Technical Service Bulletin

Cobra Motorcycle Mfg.

TSB0312 Silencer Grommets

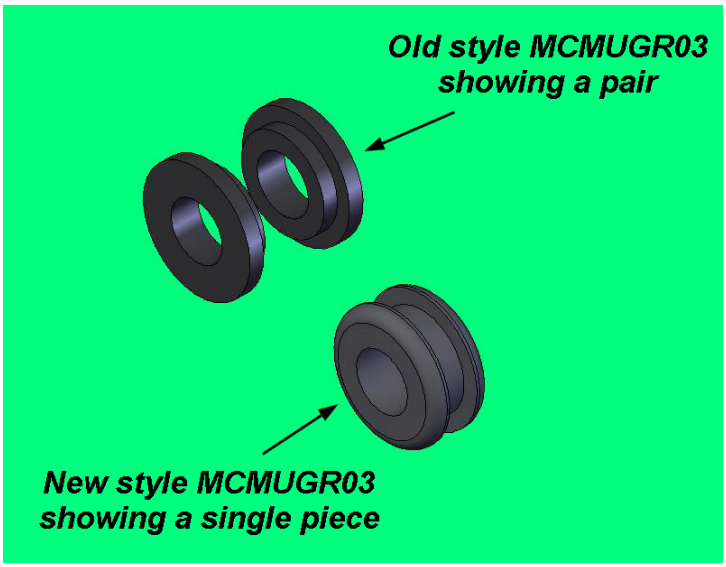
Cobra has changed silencer grommets without changing part numbers. Whereas the old style used to require two MCMUGR03 silencer grommets per bolt hole, now the new style only uses one MCMUGR03. Please order accordingly.
